CITY OF
West Linn
 PLANNING AND DEVELOPMENT

PLANNING DIRECTOR DECISION

FILE NO.: DR-12-12

REQUEST: Class I Design Review for the proposed reconfiguration of parking lots and their access points at West Linn High School, 5290/5464/5515/5527/5599/5701 West A Street

WEST LINN WILSONVILLE SCHOOL DISTRICT
 WEST LINN HIGH SCHOOL
 STUDENT PARKING LOT IMPROVEMENTS
 DEMOLITION PLAN

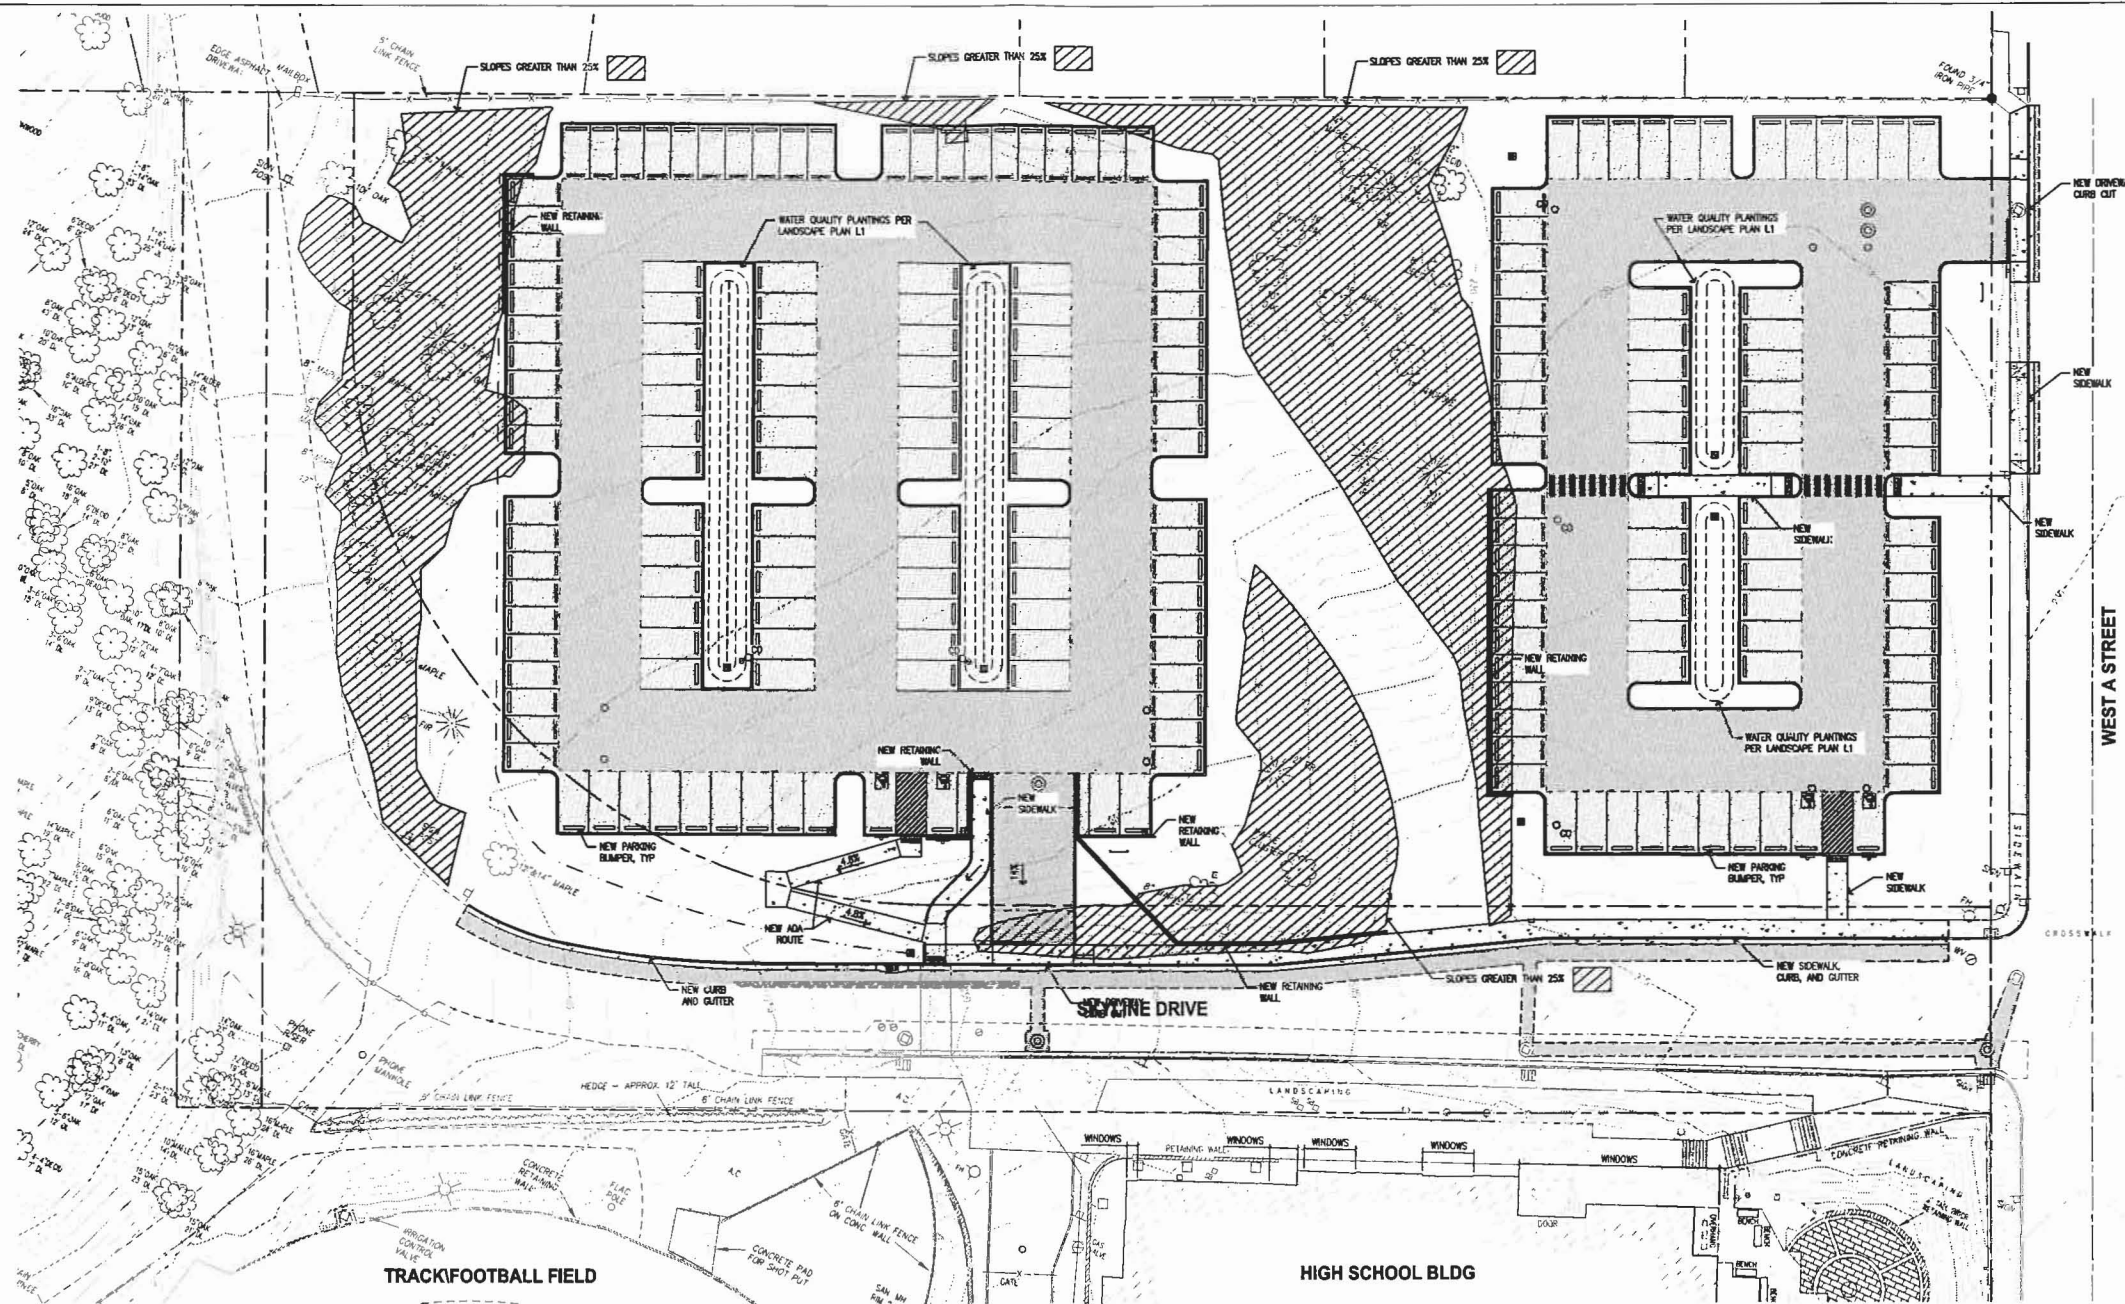
Several trees are proposed for removal as seen on Sheet C3 Demolition Plan on Page 55 of Exhibit PD-6. None are significant per the City Arborist. The slight expansion of the lots that would result in the trees' removal helps the school increase the parking spaces in the lots by 10, from 410 to 420 total on site, getting the site closer to its 423 space requirement (see Finding 5). Multiple new trees and shrubs will be incorporated around the lots for screening and landscaping as seen on Sheet L1 Planting Plan on Page 63 of Exhibit PD-6. Multiple existing trees on site will remain as well.

SITE PLAN

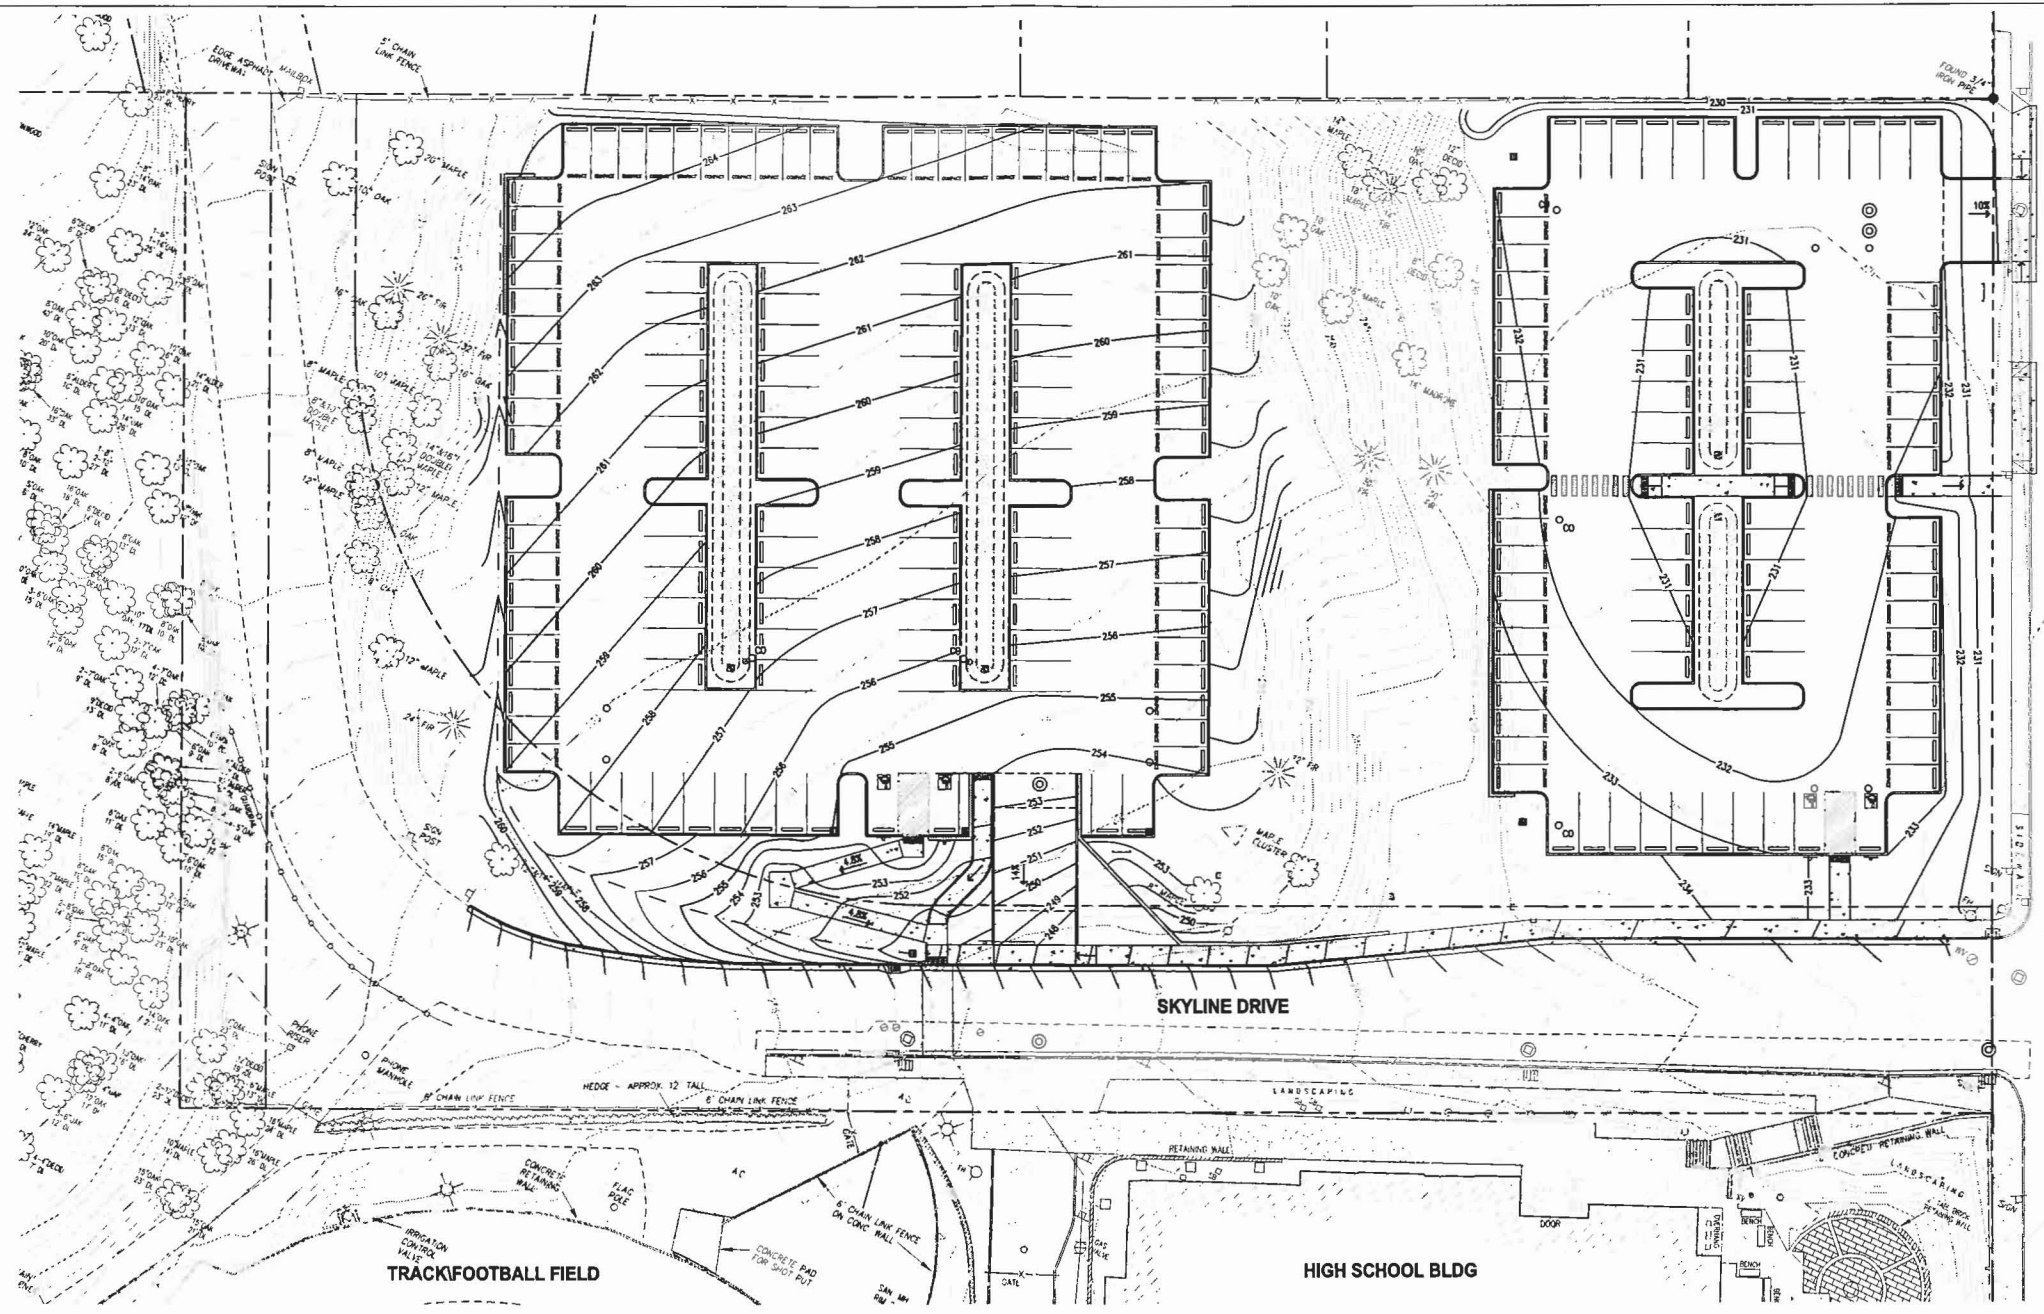
1. Tentative Plan. The improvements shall conform to Sheet C4, Site Plan, on Page 56 of Exhibit PD-6, dated May 8, 2012, except as modified by these conditions of approval.

The building occupies more than 50% of the street frontage, and this will not change upon implementation of the proposed project. All parking spaces proposed are in groups that comply with either (a), (b), or (c) above as seen in the Site Plan, Sheet C4, Page 56 of Exhibit PD-6.

- c. New Planting Plan. The applicant shall submit to staff a new planting plan complying with conditions 2a and 2b.
3. Sidewalk width. The proposed sidewalks extending between the streets and the parking lots shall be 8 feet wide along the segments where they abut driveways and/or parking spaces. The proposed retaining wall along the west parking lot's sidewalk shall be moved 2 feet to the west to accommodate this widening.

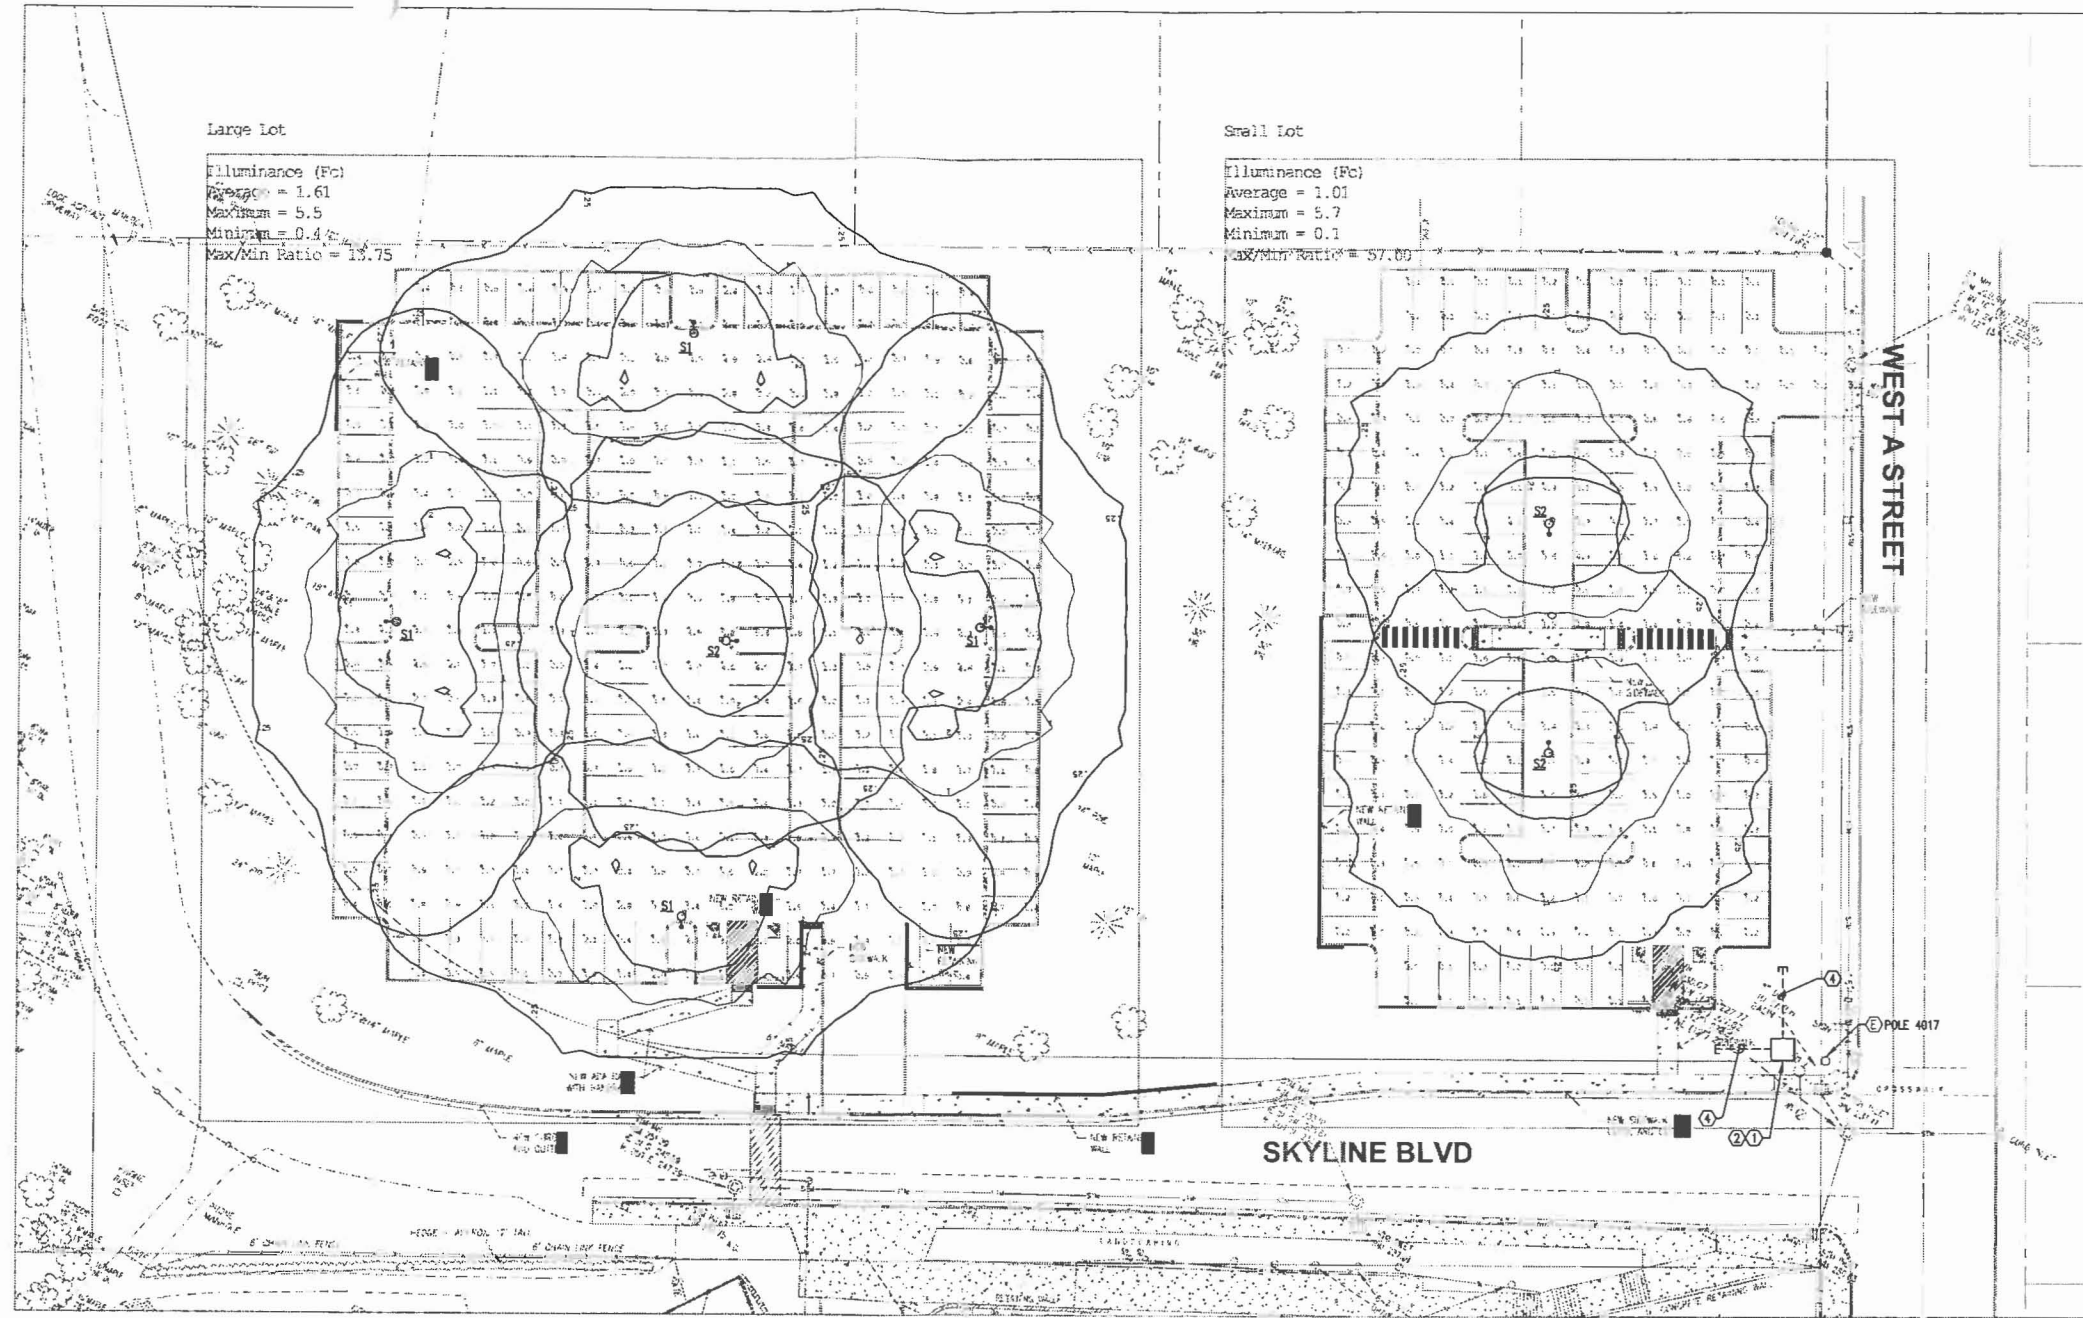
New lighting will be provided of a type that is better directed within the site. See the applicant's Lighting and Power Plan, Sheet E2.0, on Page 61 of Exhibit PD-6. The plan shows that lighting will not affect structures on adjoining properties. Effects of individual lights will overlap within the parking lots, as shown on the plan. The criteria are met.
